PRELIMINARY/ FINAL DRAINAGE REPORT FOR RIVERBEND CROSSING FILINGS NO. 1 AND 2

PCD FILE NOS:
SP 187
SF 1843
SF 1844

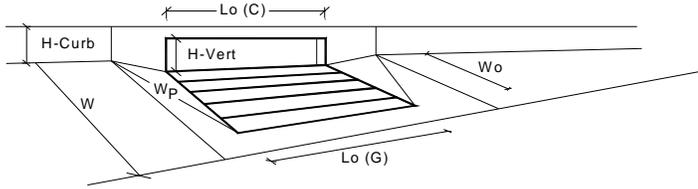
B12 inlet size is 15' per the inlet calculation.
Unresolved. Update to 15'

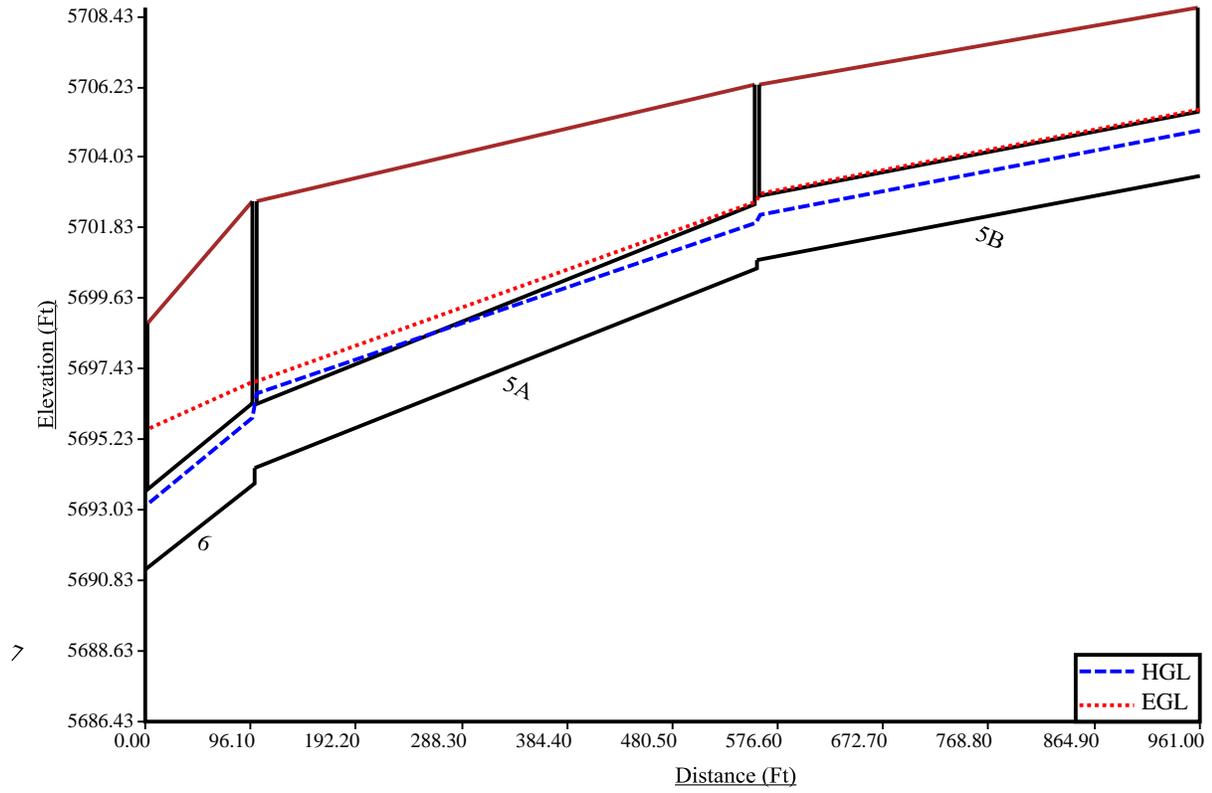
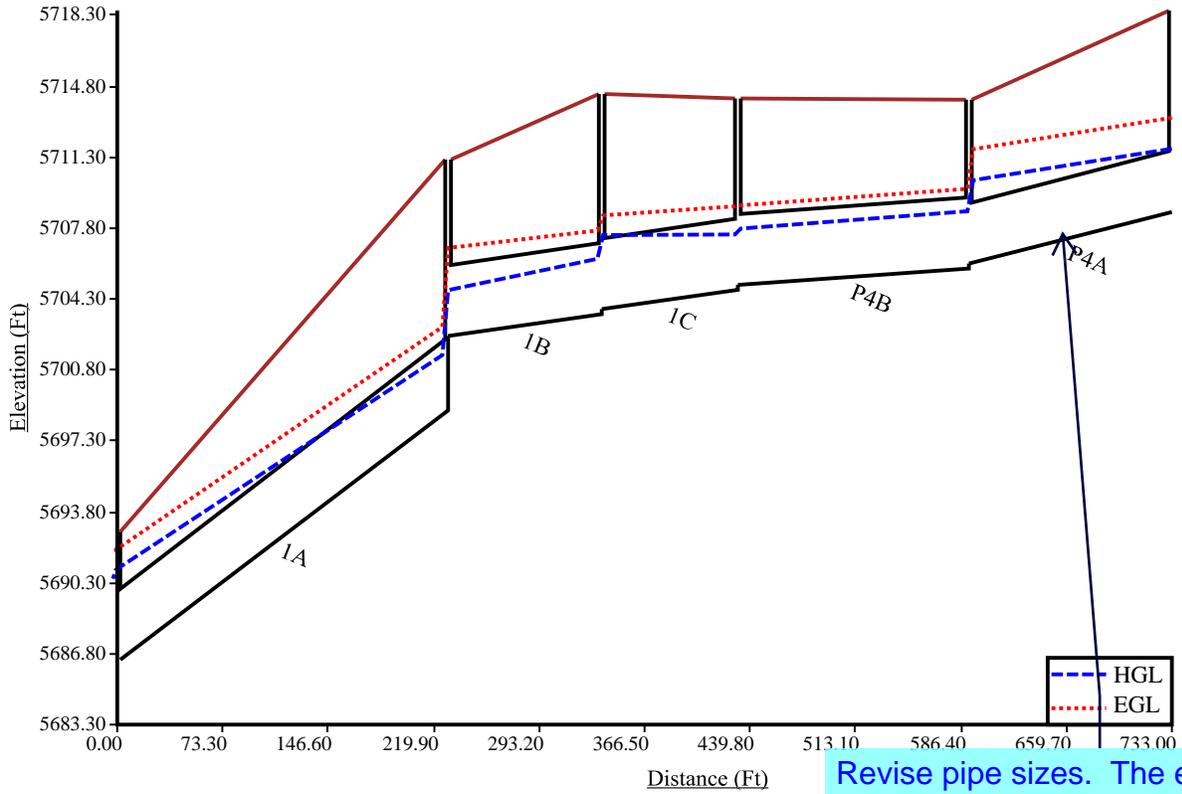
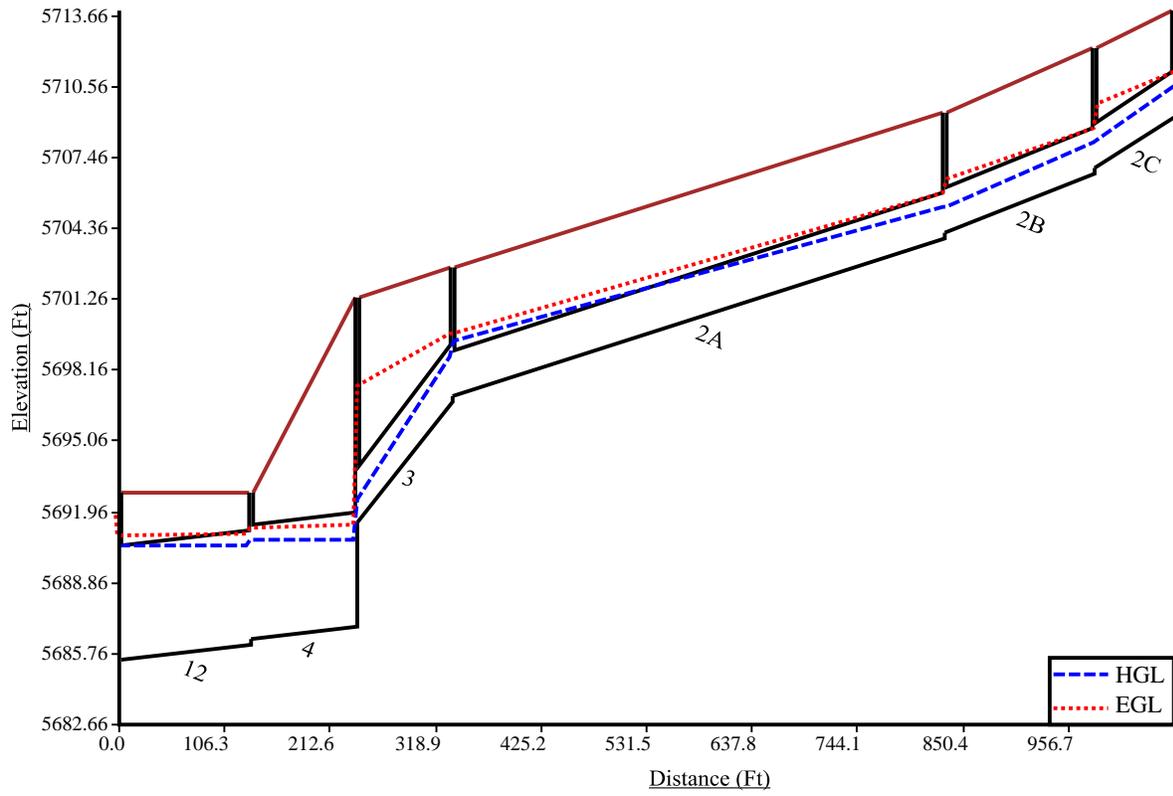
Revise pipe sizes. The entire section is under pressure.

Per ECM Section 3.3.1.D
Unresolved.

Design Procedure Form: Extended Detention Basin (EDB)

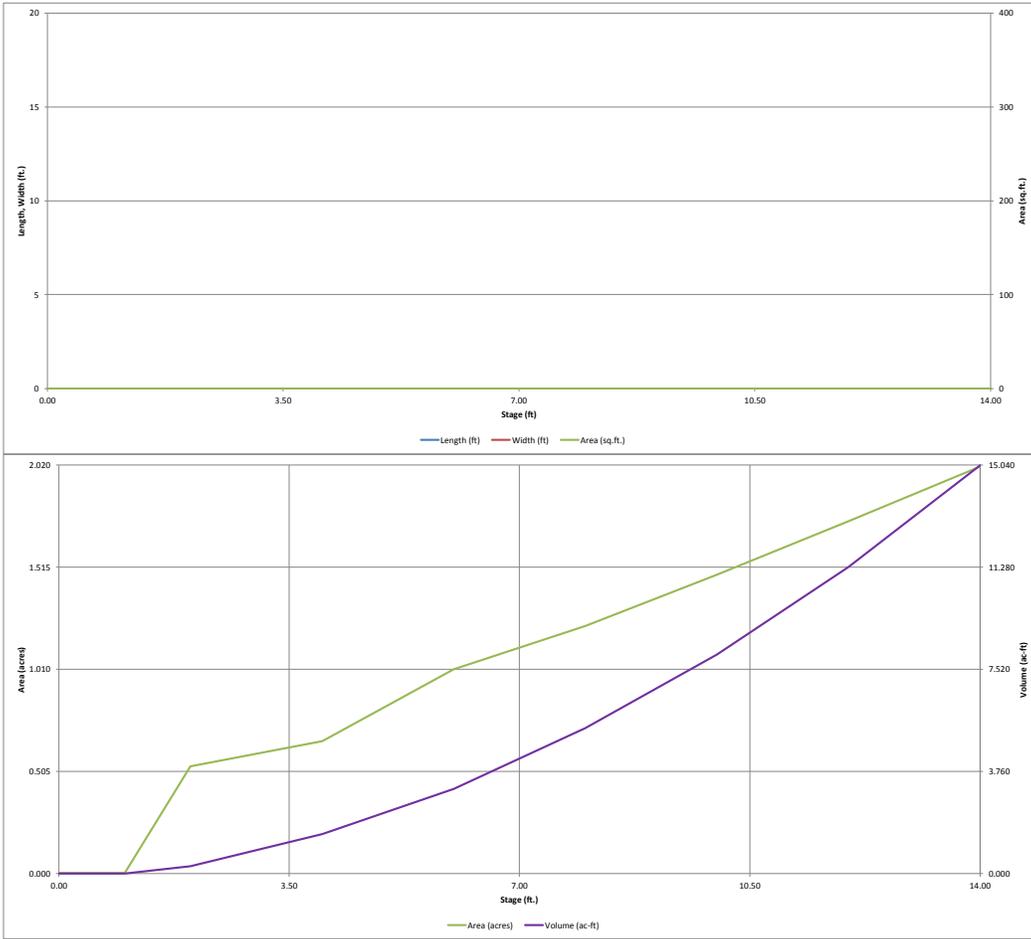
Update. Does not match construction plans

This forebay calculation is for Forebay 'A'.
Provide the calculation for Forebay 'B'

Detention Basin Outlet Structure Design

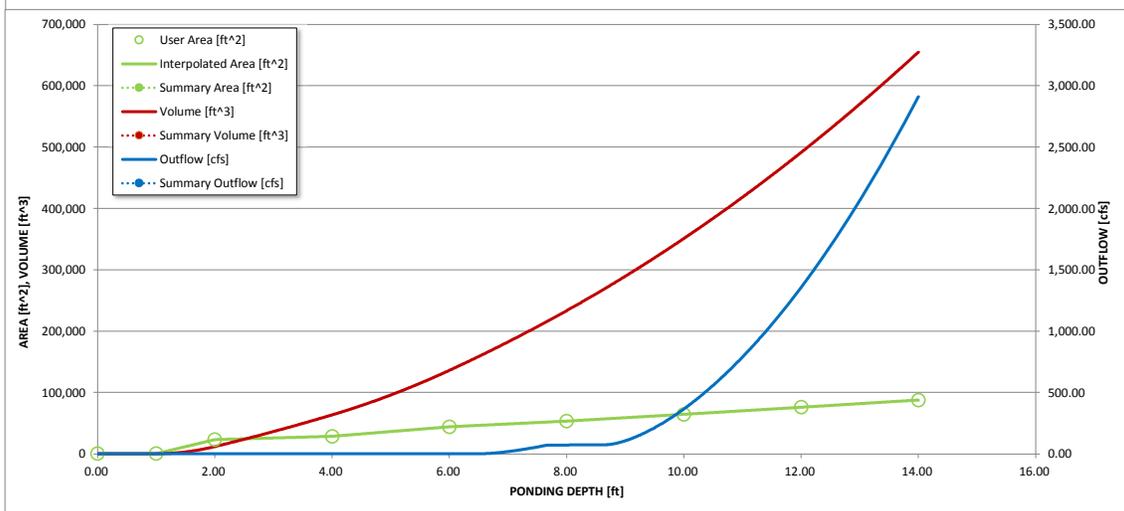
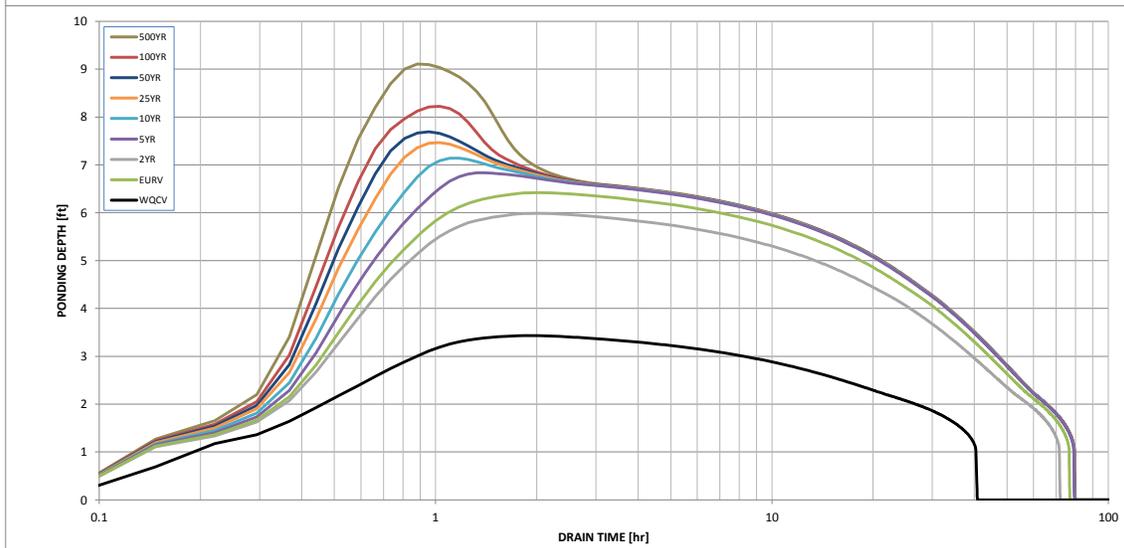
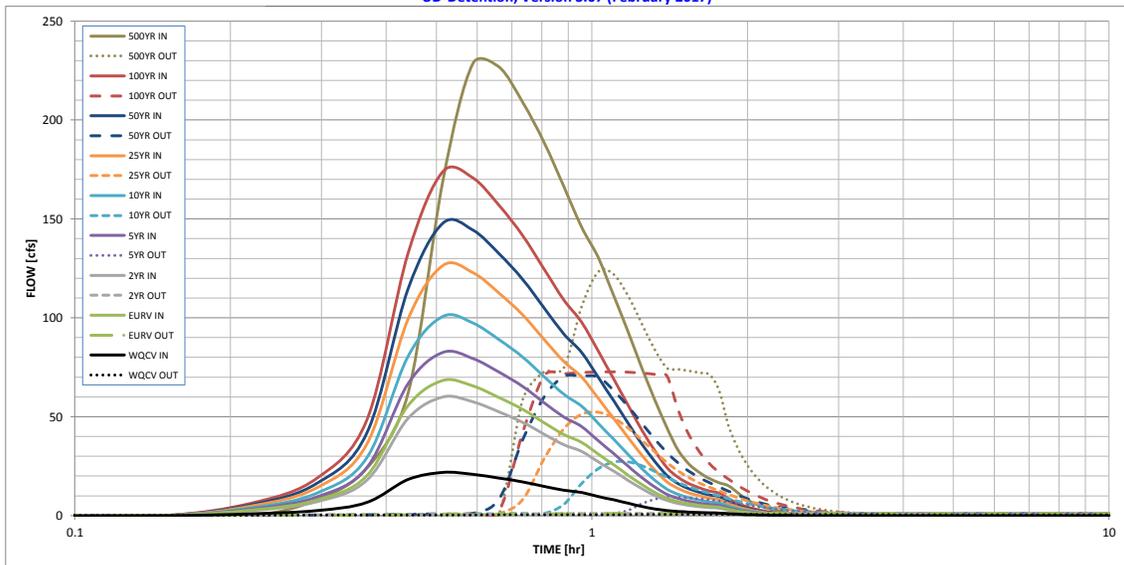
Update outlet structure. FSD must release at or below historic Qs

EMERGENCY SPILLWAY PROFILE

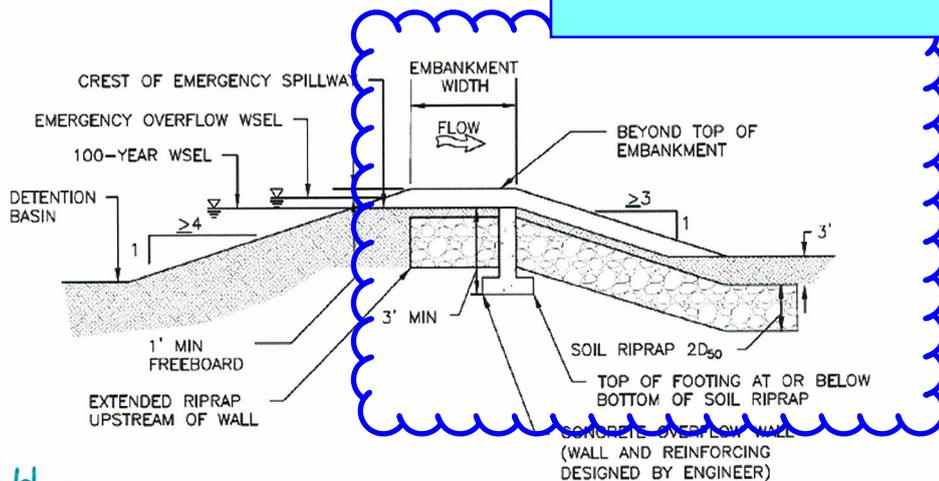
Update construction plans to show this profile which shows soil riprap extending beyond the top and buried 3' below and the concrete overflow wall.

RIVERBEND CROSSING
 PROPOSED DRAINAGE PLAN

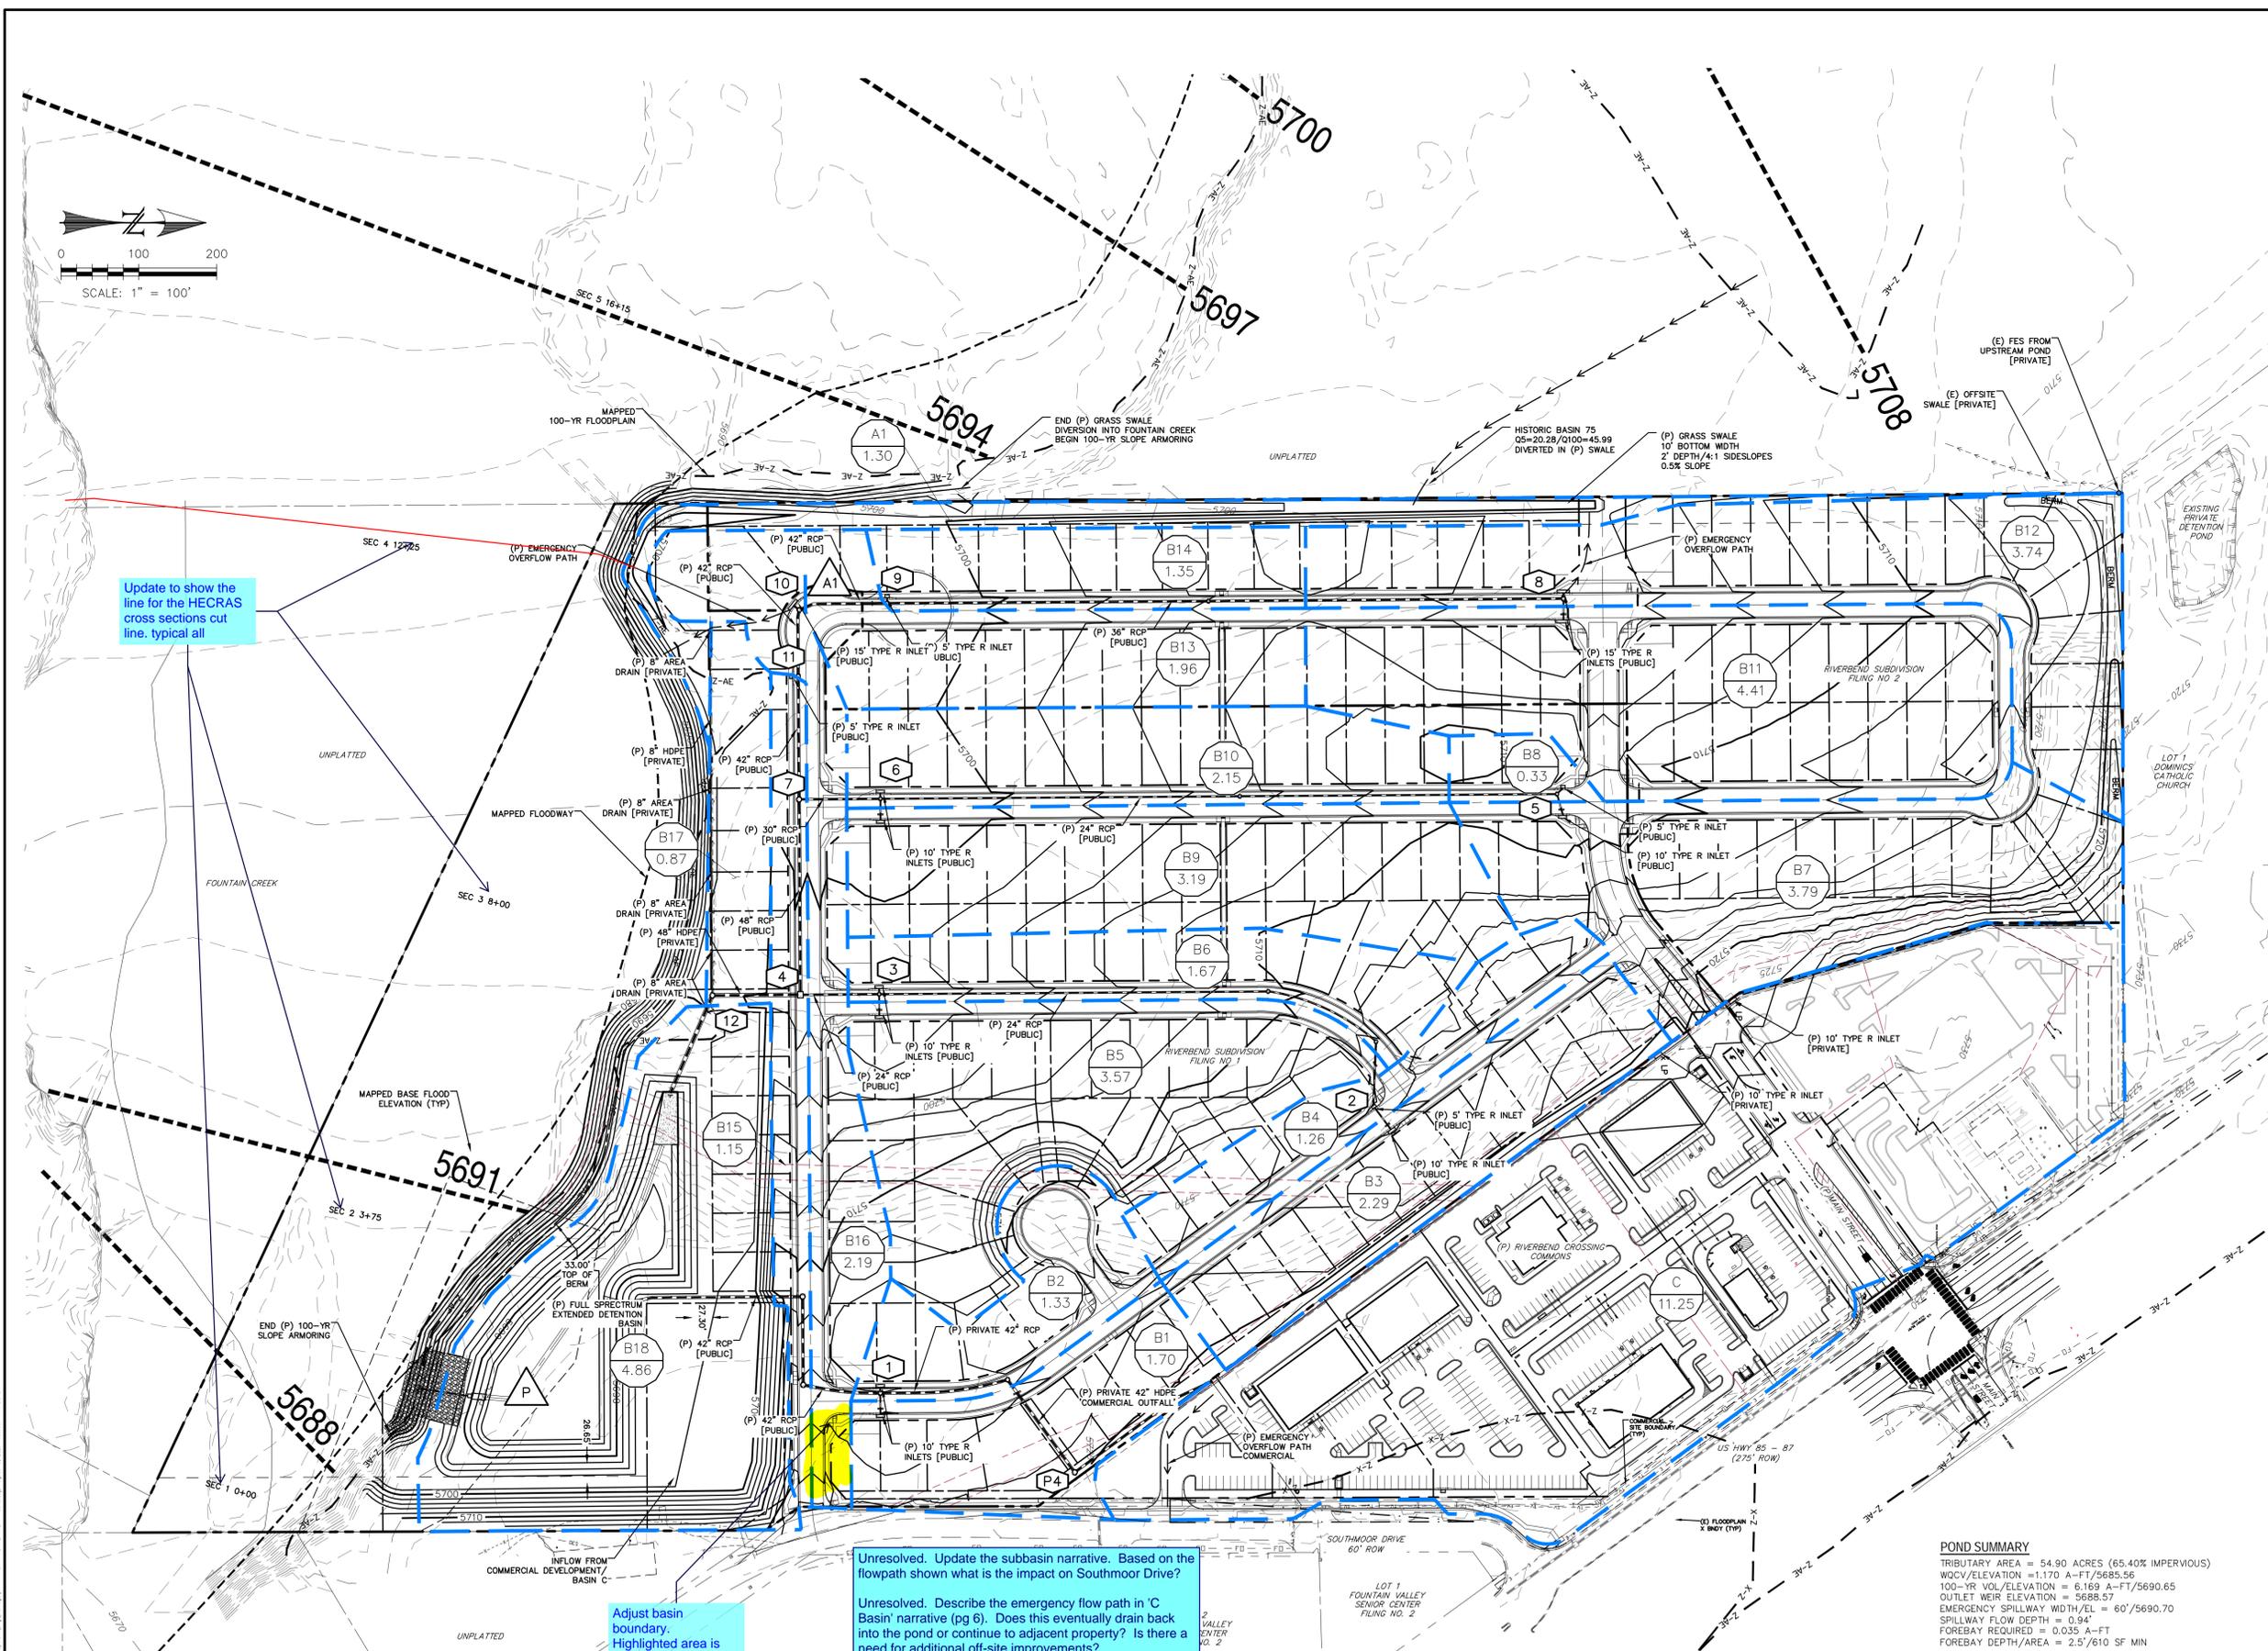
Update to show the line for the HECRAS cross sections cut line. typical all

Adjust basin boundary. Highlighted area is shown to drain towards the inlet in basin B1
